## ADDENDUM NO. TWO (2)

Date: 03/28/2022 Architect's Project No. A20-159

Project: IFB 22-003 Sugar Hill Historic Cemetery

Client: City of Sugar Hill

C2.1

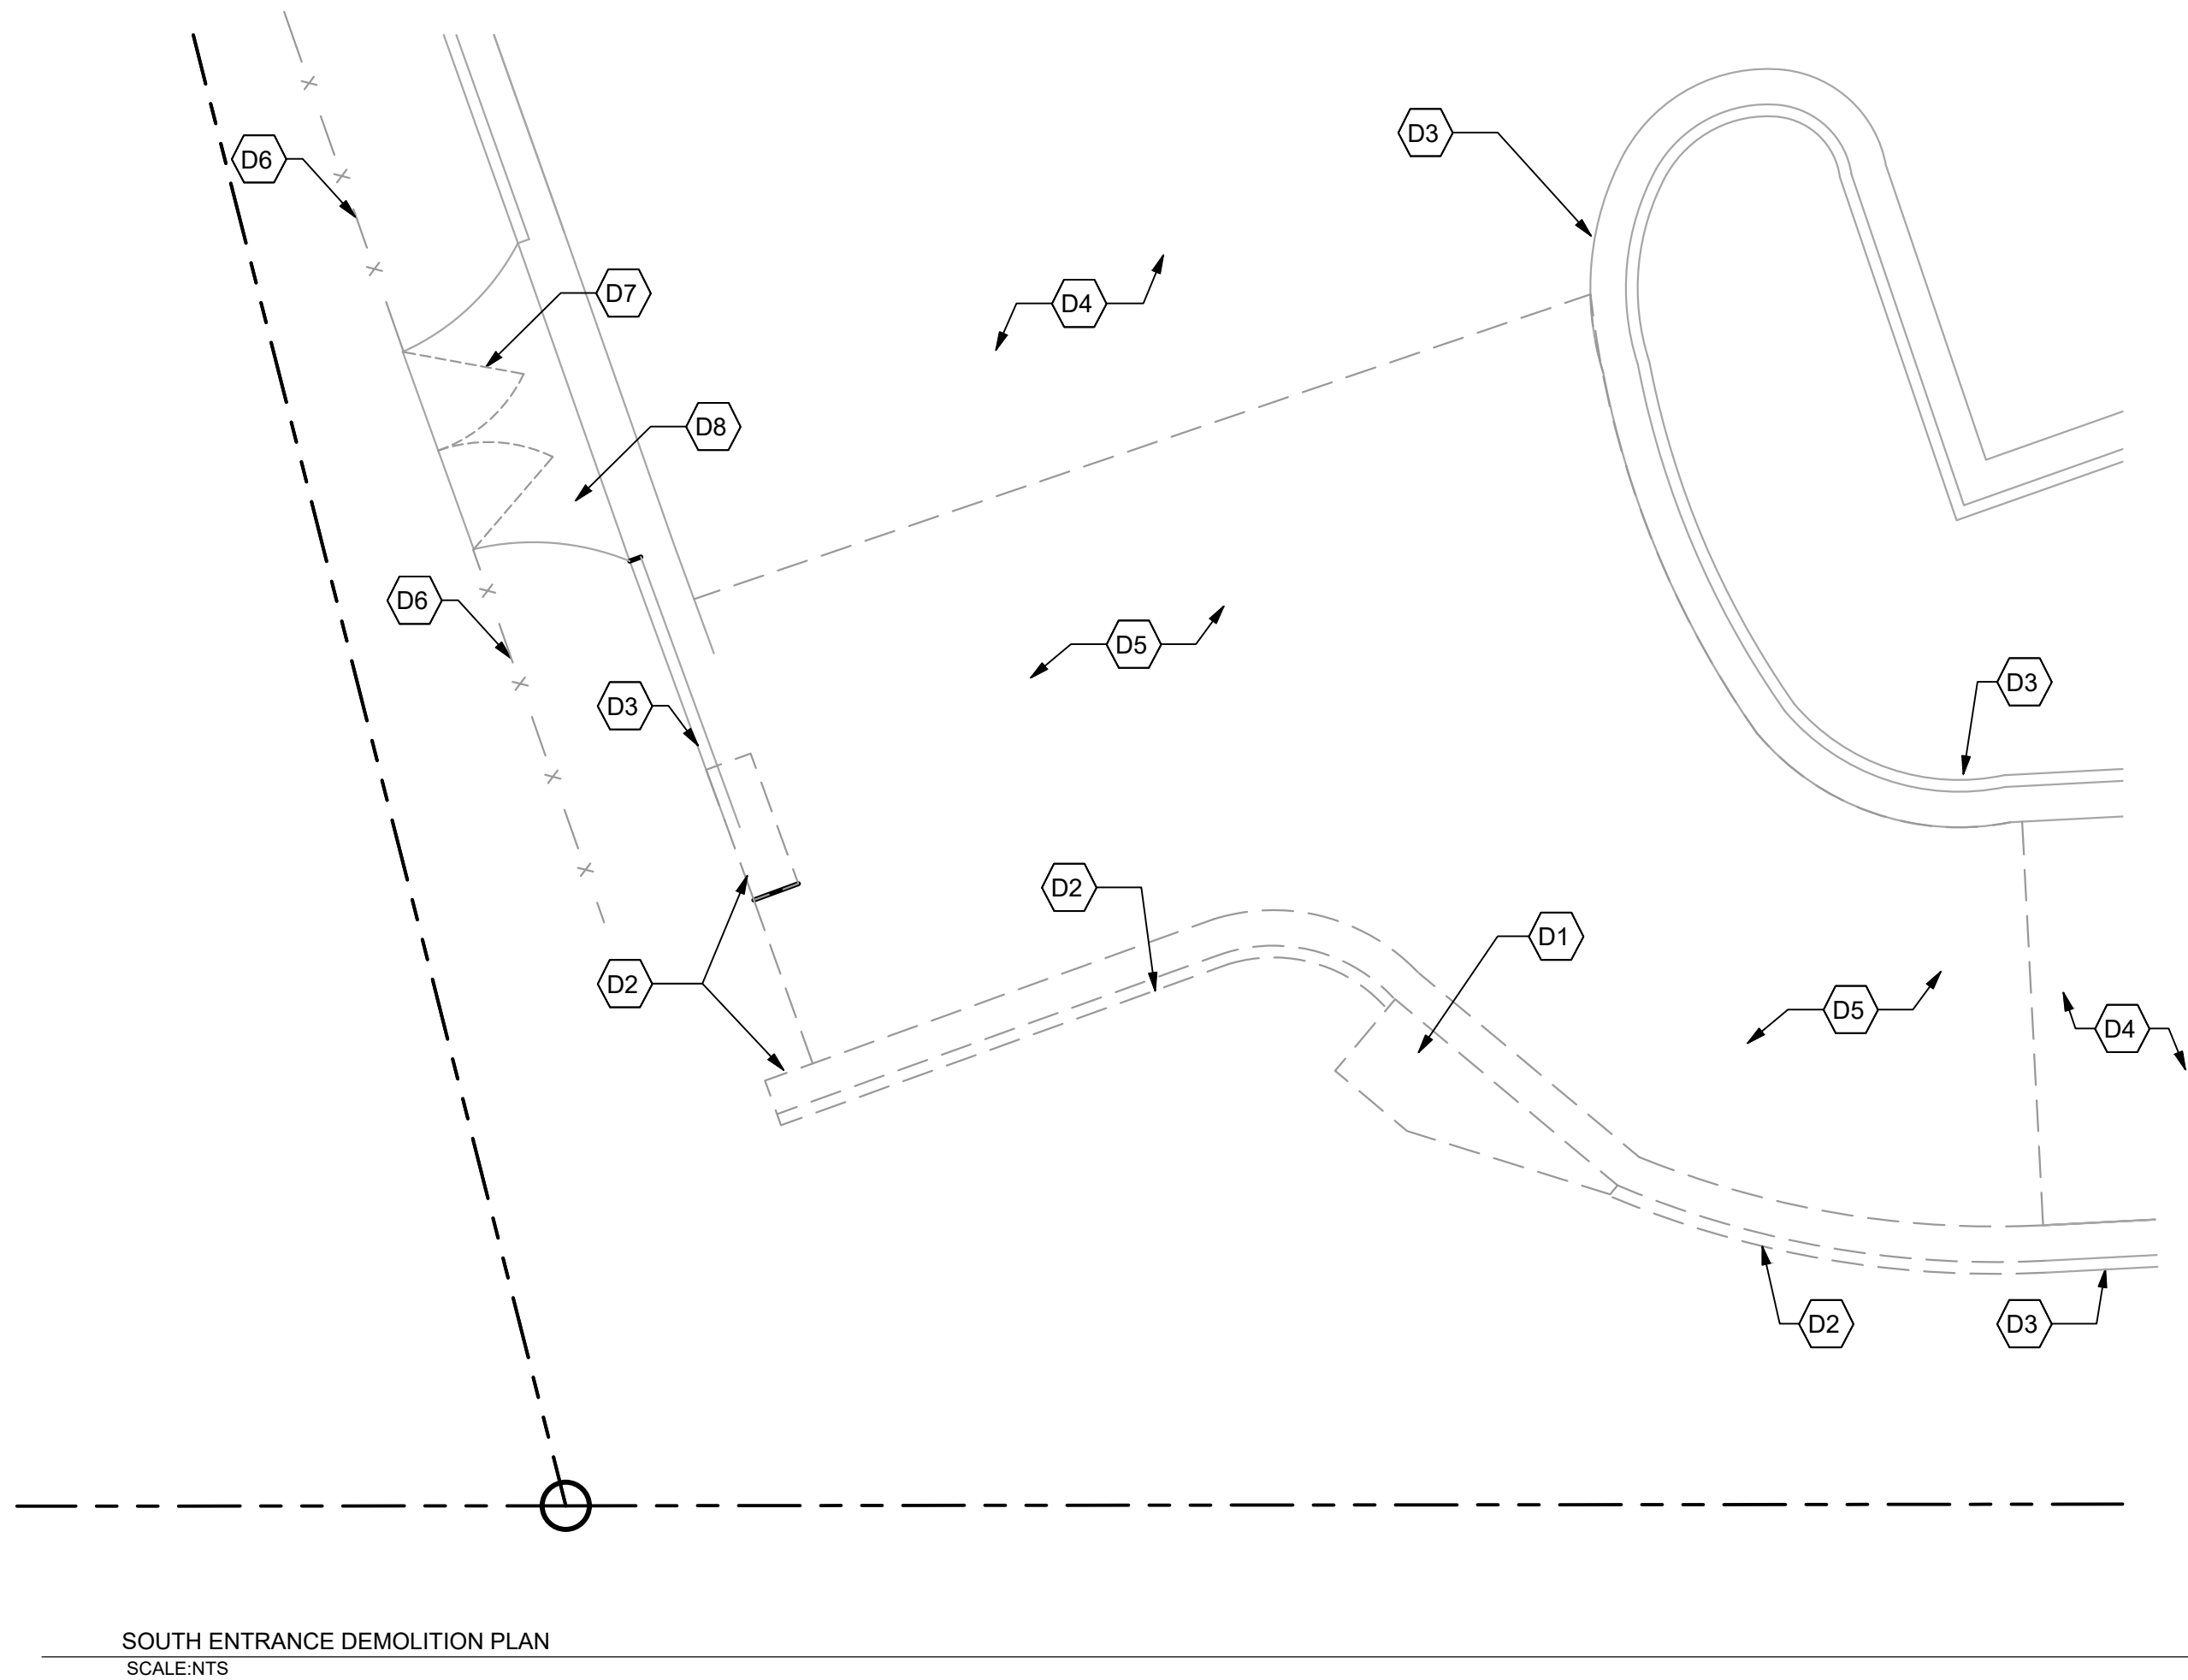
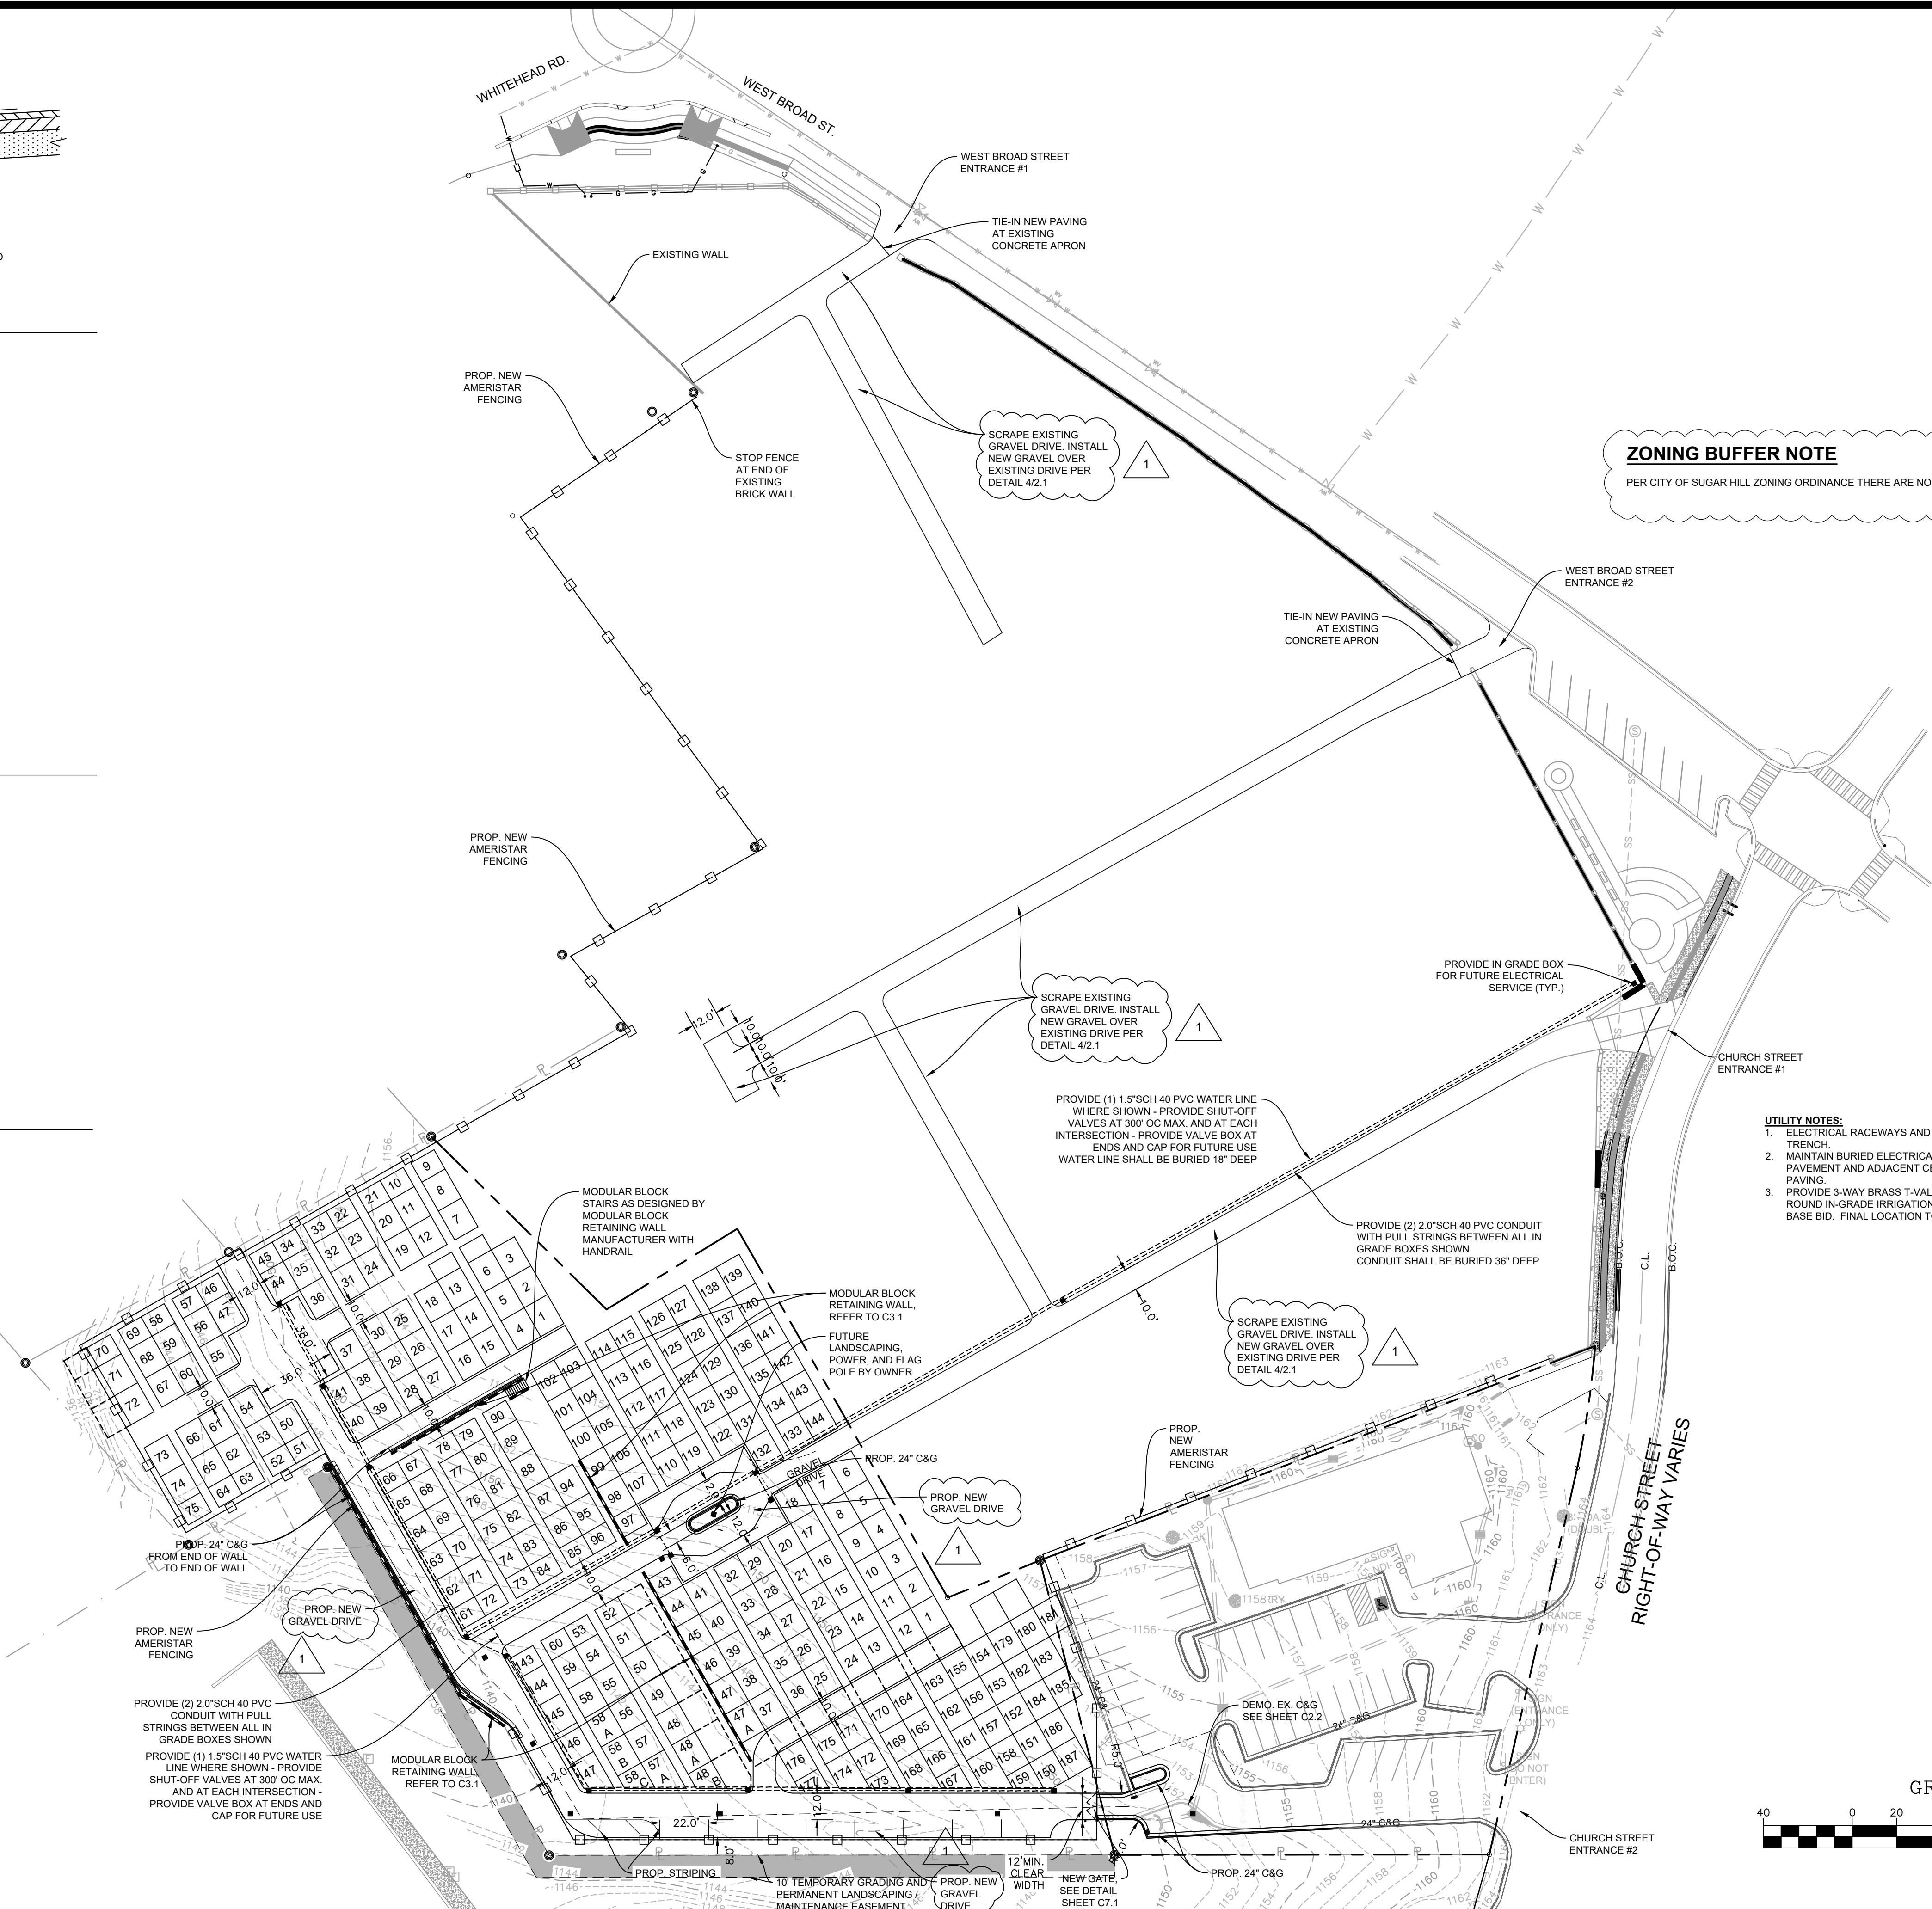
1. All existing and new drives within the property boundaries shall be paved with gravel paving per detail 4/C2.1 as part of the base bid. Asphalt paving of these areas shall be included as an add alternate. Refer to attached revised sheet C2.1, Bid Form and Section 012700 Unit Prices and Allowances.

2. Omit all grading activities and reduce scope of erosion control needed at cemetery plots 58 – 75 in northwest corner of property. Refer to revised sheets C2.1, C3.1 and C5.1.

3. Reduce new paving required and limits of disturbance at cemetery plots 36 & 37 in northwest corner of property. Refer to revised sheets C2.1, C3.1 & C5.1.
